**Lichterman Nature Center Major Maintenance – Phase 1**

**Addendum No. 1**

Name: Lichterman Nature Center  
Major Maintenance – Phase 1  
A2H #: 21513

Addendum #: 1  
Date of Issuance: 4/29/25  
Sent Via: Email  
Total Pages: 26

# DESIGN STANDARD FOR CONSTRUCTION SIGN WITH CITY COUNCIL MEMBERS

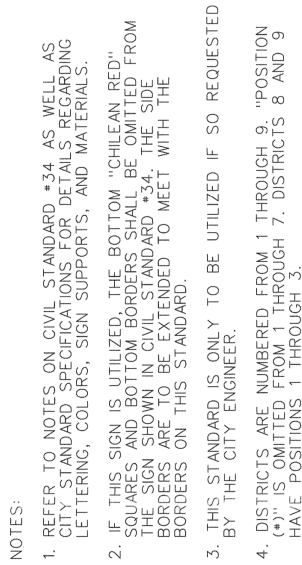
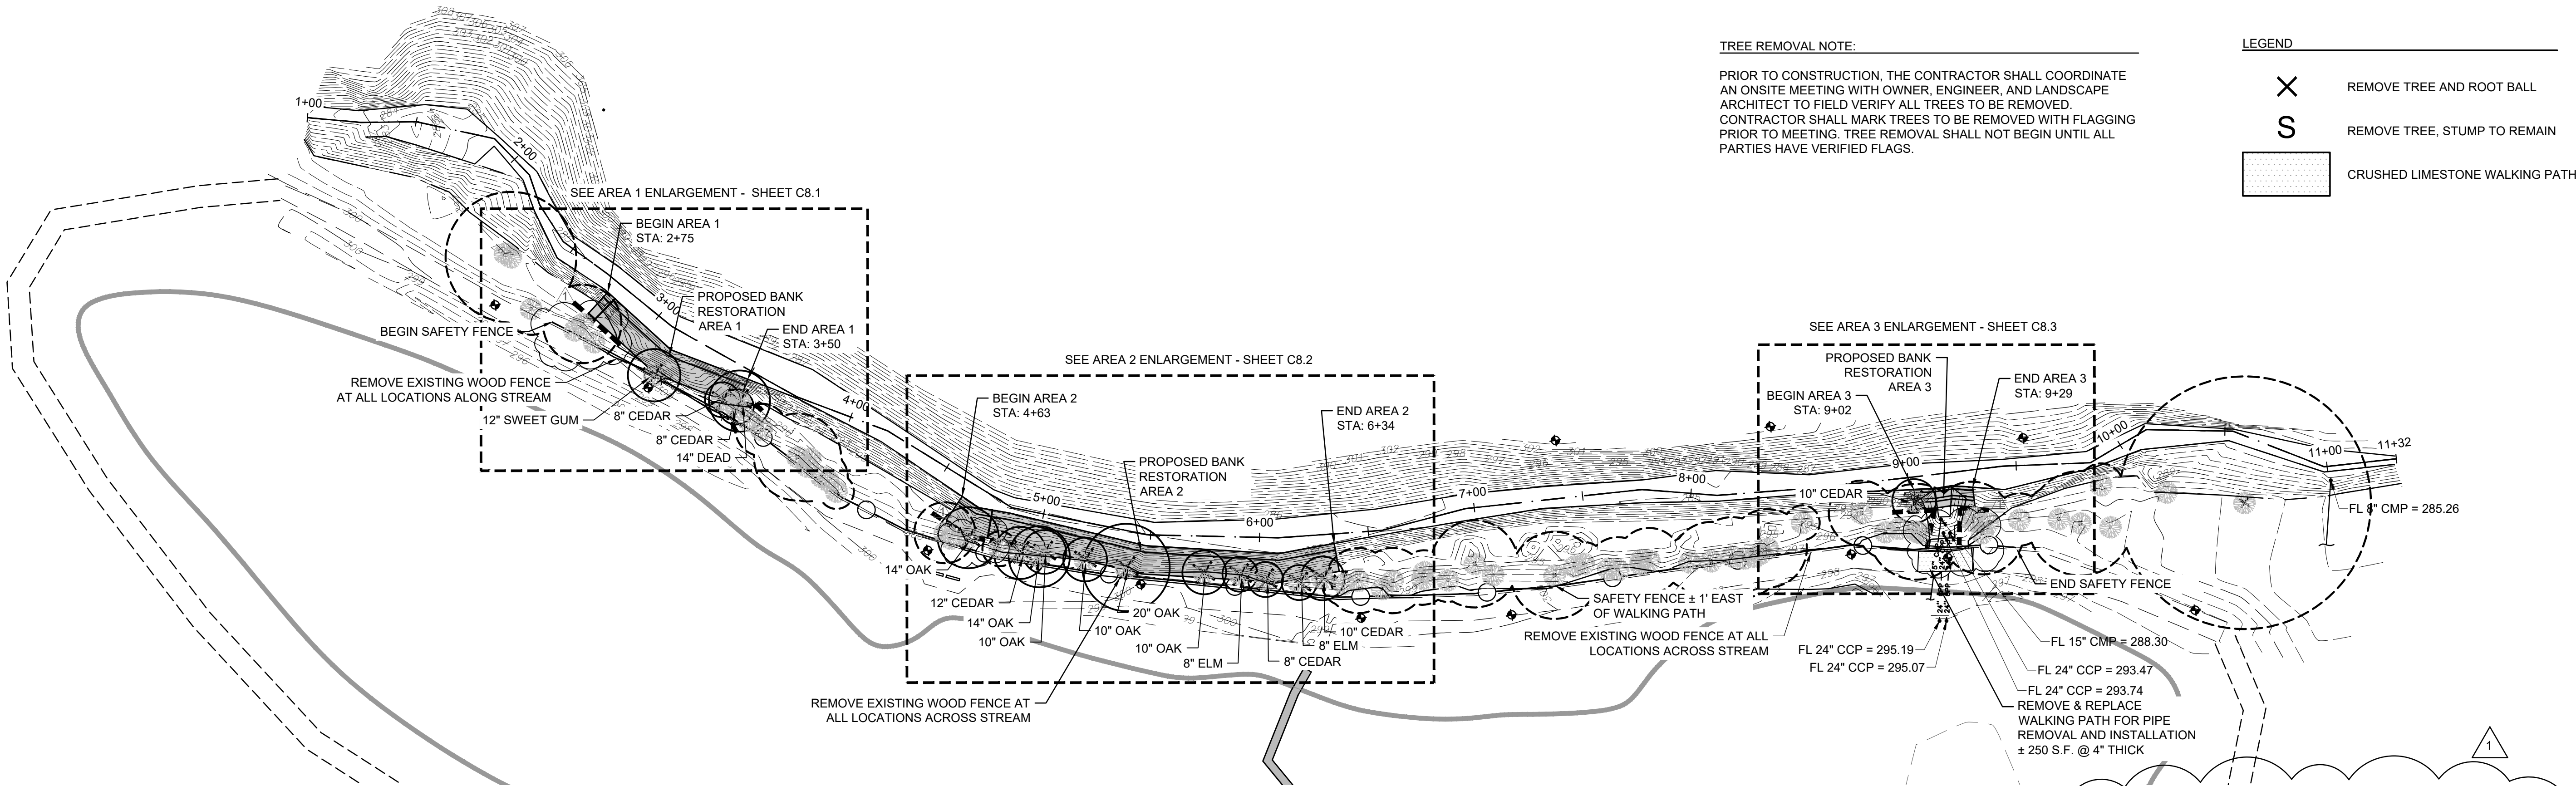
- #18** ML A2H to provide Signage Detail in Addendum #1
- #19** ML, CW, JK Open for questions from Bidders:
- Question 1:  
Can L1.1 and L1.2 be reissued for text to be easier to read?  
CW – These are existing scans and can't be revised.  
JK – There may be plans at Lichterman Nature Center that can be provide to A2H.

4. SIGN TO BE EITHER EXTERIOR GRADE 3/4" PLYWOOD WITH SUFFICIENT 2X4'S FOR STABILITY OR 0.08" GAUGE ALUMINUM SHEET METAL PER CITY SPECIFICATIONS. OTHER APPROVED MATERIAL SUITABLE FOR SIGNING MAY BE APPROVED BY THE CITY ENGINEER.

5. PROVIDE ADEQUATE SUPPORTS FOR SIGN AS SITE CONDITIONS MAY REQUIRE TO PERMIT PUBLIC VIEWING. IF ALUMINUM SHEET METAL IS UTILIZED, ALTERNATIVE POSTS MAY BE UTILIZED IN CONJUNCTION WITH BOLTS, WASHERS, AND OTHER HARDWARE PER CITY SPECIFICATIONS.

B1 PLAN VIEW OF STREAM

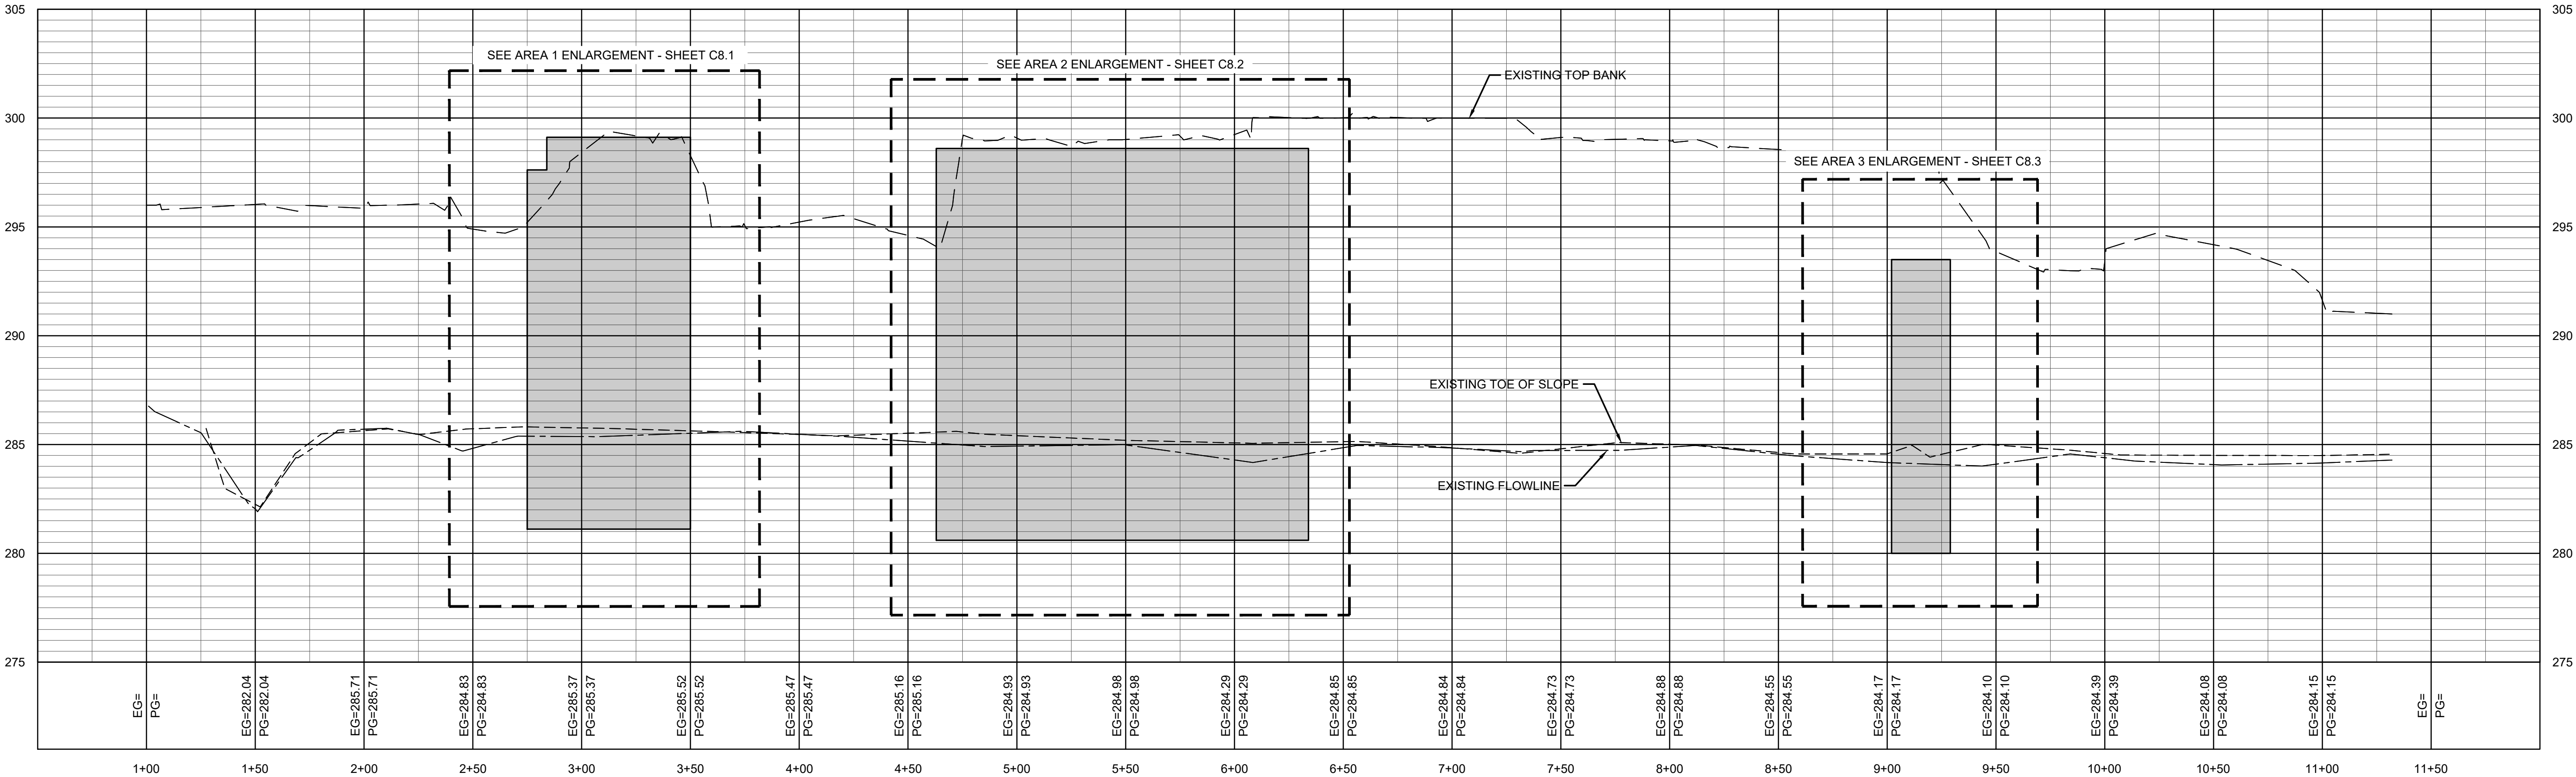
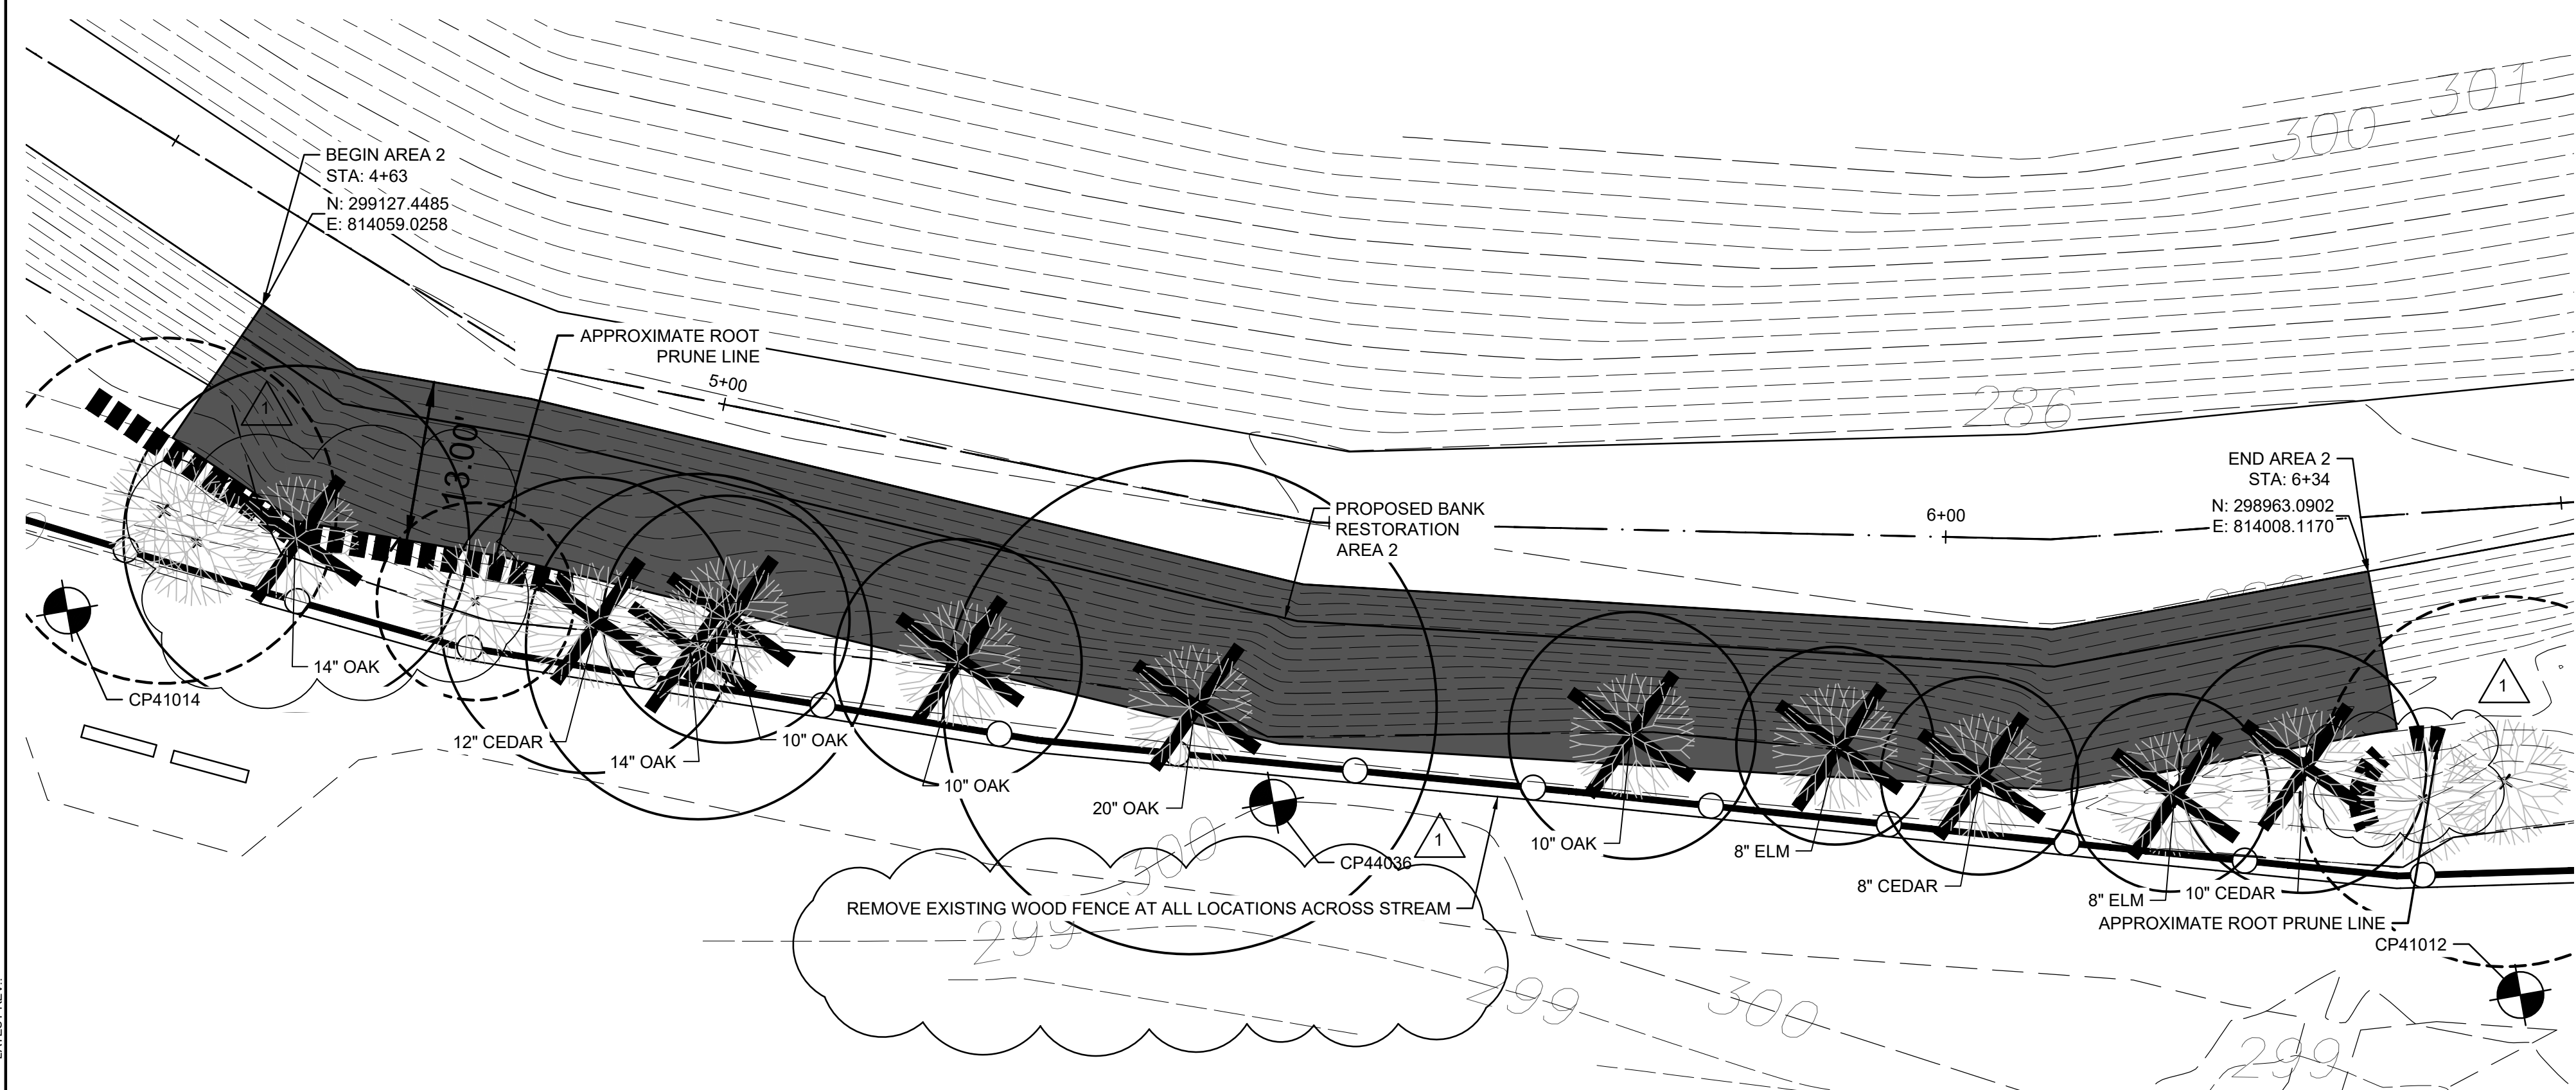
- *Yes. There is an existing system that can lower the lake level but will need to see if it is operational.*
6. Review the existing trees to be removed since the redesign of the stream.

- *See revised Sheet C5.1 attached to this addendum.*
7. With the bridge being removed, is there anything being provided to let pedestrians know the trail dead-ends and is barricade be provided?

PRIOR TO CONSTRUCTION, THE CONTRACTOR SHALL COORDINATE AN ONSITE MEETING WITH OWNER, ENGINEER, AND LANDSCAPE ARCHITECT TO FIELD VERIFY ALL TREES TO BE REMOVED. CONTRACTOR SHALL MARK TREES TO BE REMOVED WITH FLAGGING PRIOR TO MEETING. TREE REMOVAL SHALL NOT BEGIN UNTIL ALL PARTIES HAVE VERIFIED FLAGS.

- X REMOVE TREE AND ROOT BALL
- S REMOVE TREE, STUMP TO REMAIN
- CRUSHED LIMESTONE WALKING PATH
